Re: Docket No. 14-AAER-1

These comments related to Title 20 rulemaking for Small Diameter Directional Lamps and LED Lamps are provided by Soraa Inc., based in Fremont California. Soraa develops and manufactures LED lighting products based on newly developed GaN on GaN LED technology and was founded by Nobel Prize winner Shuji Nakamura and professors Steven DenBaars and James Speck from the University of California Santa Barbara. We support the California Energy Commission in its goal to promote efficiency and conservation, cutting-edge research, and support of development of renewable energy resources. We appreciate the opportunity to provide comments to Title 20 rulemaking.

Comments related to 1605.3 State Standards for Non-Federally Regulated Appliances  
(k) Lamps (6):

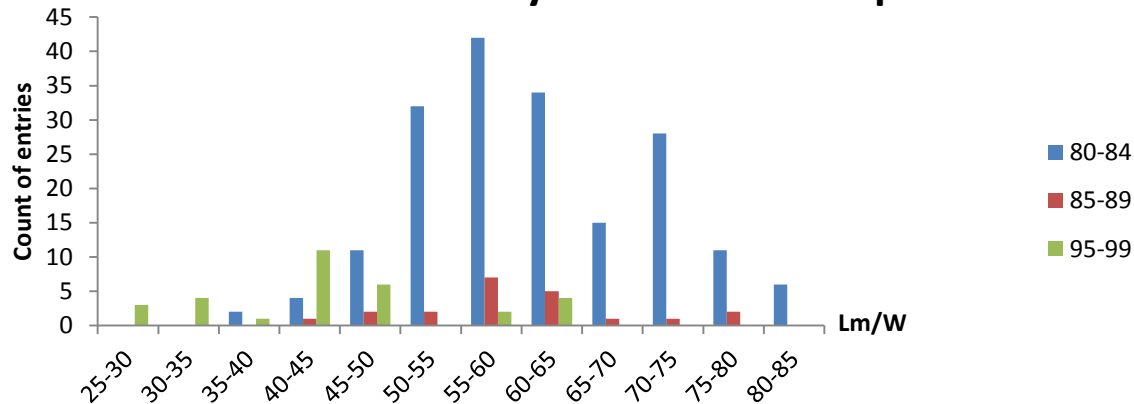
For a sample size of 237 products submitted to Lighting Facts database (LED Lighting Facts Products) since 1/1/2013, the average efficacy of LED SDDL products in September 2014 between 80 and 90CRI was 61lm/W. LED SDDL between 90 and 100CRI had an average efficacy of 44lm/W.

Assuming an average efficacy improvement of 10% per year, Soraa predicts that the average efficacy of LED SSDL between 80 and 85CRI will be 78lm/W in 2018. For 90-100CRI we predict 58lm/W in 2018. A proposed minimum requirement of 80lm/W (California Energy Commission, 2014) would make products with high color rendering index (90 or higher, for example 95 or 97CRI) too expensive to manufacture and would put high color rendering products at a severe disadvantage in the market place.

Based on analysis of efficacy of currently available LED Small Diameter Directional Lamps (LED SDDL) and expected improvements over the coming years, Soraa recommends that the luminous efficacy requirement be changed as per the following formula, derived from the proposed compliance score for LED Lamps (California Energy Commission, 2014).

$$3 \times CRI + Efficiency \geq 340$$
$$Efficiency \geq 55lm/W$$
